TRENCH DATA

HOWARD COUNTY HEALTH DEPARTMENT

Re: Brantwood 3/1

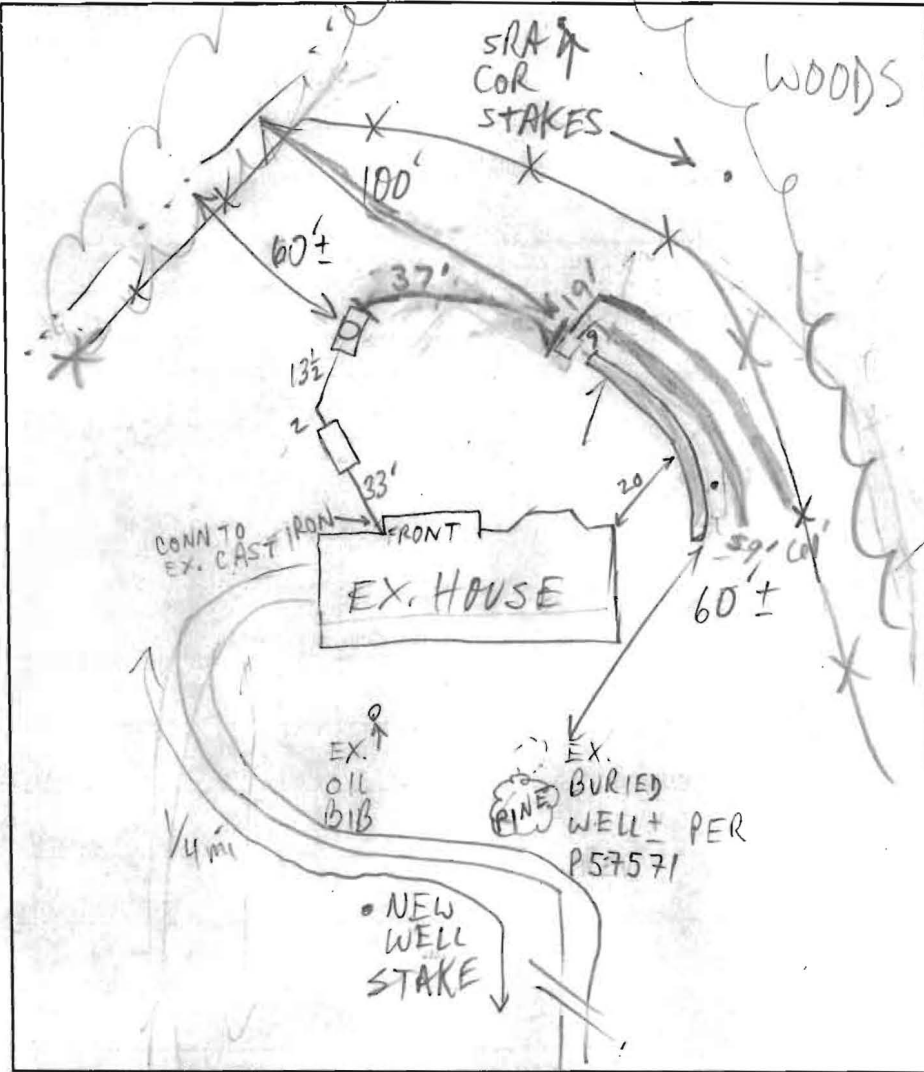
PRE-CONSTRUCTION INSPECTION: 7/30/01 AM OK TO START; EX. WELL TO BE REPLACED IN IMMEDIATE FUTURE (MR)

INSPECTION COMMENTS: 7/30/01 PM OK TO COVER HOUSE CONN, FIRST TRENCH (MK)
7-31-01 OK TO COVER TRENCHES. LEAVE UNCOVERED THE D.B. BOX FOR PUMP/ALARM INSPECTION (KG/MR)

8-28-01 will cement abandon well WPT of (KG) 10/16/03
Called TCR Home improvements bringing to their attention that a pump test was never called in. Called S. Carroll Backhoe, too. Informed TCR

To ensure septic pump & septic alarm are on two sep. breakers. (KN)
